# Access Compliance Report

## Public Rights-of-Way

### (Curb Ramps)

Intersection ID: 27397	Main Street: ELM_LN	Cross Street: BALLANTYNE_COMMONS_PY	Location: NW
ADA ID: 3B8A634AFD25	Ramp Type: Perp	Initial Pass/Fail: Fail	Overall Compliance: No
			Severity Score: 21.25

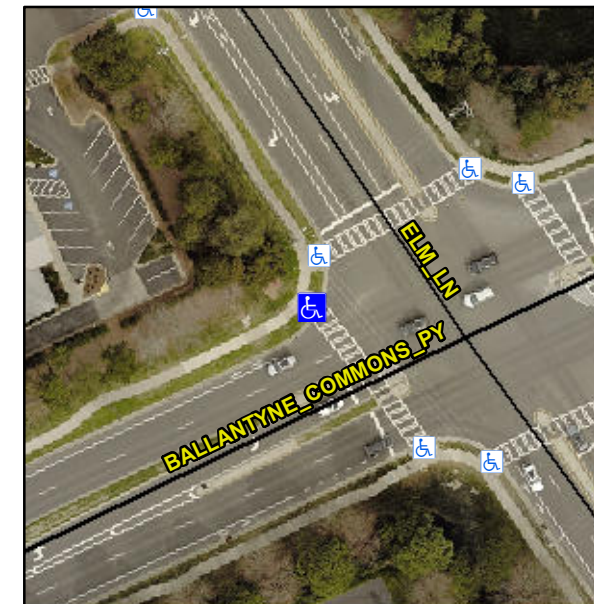
**Not Found, R304.5.1, R304.2.2**

Compliance	Description	Data	Compliance	Description	Data
N/A	Ramp Length (in)	80.0	No	Ramp Slope (%)	8.4
No	Ramp Width (in)	42.0	Yes	Ramp XSlope (%)	2.0
N/A	Flare Type LT	N/A	N/A	Flare Type RT	N/A
N/A	Flare Slope LT (%)	N/A	N/A	Flare Slope RT (%)	N/A
N/A	Flare Traversable LT?	N/A	N/A	Flare Traversable RT?	N/A
N/A	Landing Length (in)	N/A	N/A	DWS Provided?	N/A
N/A	Landing Width (in)	N/A	N/A	DWS Contrast?	N/A
N/A	Landing Slope (%)	N/A	N/A	DWS Length (in)	N/A
N/A	Landing X Slope (%)	N/A	N/A	DWS Full Width?	N/A
N/A	Landing Curb? (Y/N)	N/A	N/A	DWS Offset (in)	N/A
N/A	Shared Landing?	N/A			
N/A	Gutter Ponding?	N/A	N/A	Gutter Slope (%)	N/A
N/A	Gutter Lip Ht (in)	N/A	N/A	Gutter X Slope (%)	N/A
N/A	Painted X Walk1?	Yes	N/A	Painted X Walk2?	N/A
	X Walk 1 Direction	To SE		X Walk 2 Direction	N/A
N/A	X Walk 1 Width (in)	112.0	N/A	X Walk 2 Width (in)	N/A
	X Walk 1 Slope (%)	2.8		X Walk 2 Slope (%)	N/A
	X Walk 1 X Slope (%)	0.6		X Walk 2 X Slope (%)	N/A

**Remove & Replace Entire Ramp.**
